SERVICE ACTION

Reference number:	SA-01-1143	Issued: 21 March, 2019
Subject:	Lamy Pen Holder – Incorrect Colour	
Model(s):	Vanquish Zagato	
VIN range:	Refer to the separately published list of Vehicle Identification Numbers (VINs)	
Applicable to:	All Dealers	
Distribute to:	After Sales Manager Executive Manager Service Manager Sales Manager	Warranty Staff Technician(s) Parts Staff

Figure 1

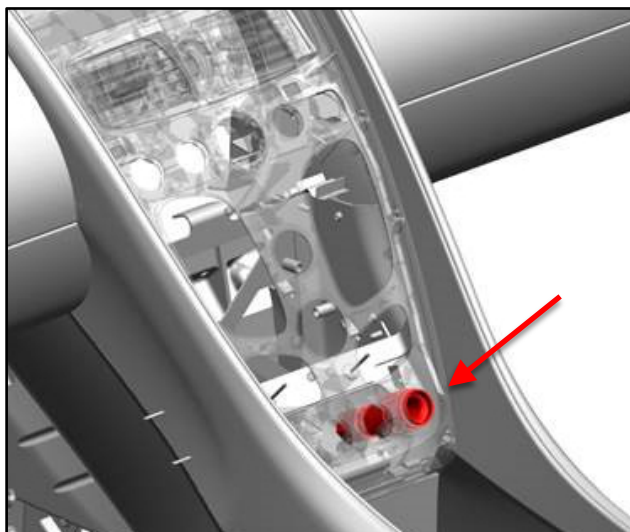
The colour of the Lamy Pen Holder is incorrect on some Vanquish Zagato vehicles. Do the procedure that follows if a vehicle has a Lamy Pen Holder of the incorrect colour.

1. Remove the Centre Stack Assembly (refer to Workshop Manual Procedure 15.01.CB).
2. Remove the Lamy Pen Holder (refer to Workshop Manual Procedure 18.03.AE and Figure 1).

3. Install a new Lamy Pen Holder of the correct colour (refer to Workshop Manual Procedure 18.03.AE).
4. Install the Centre Stack Assembly (refer to Workshop Manual Procedure 15.01.CB).
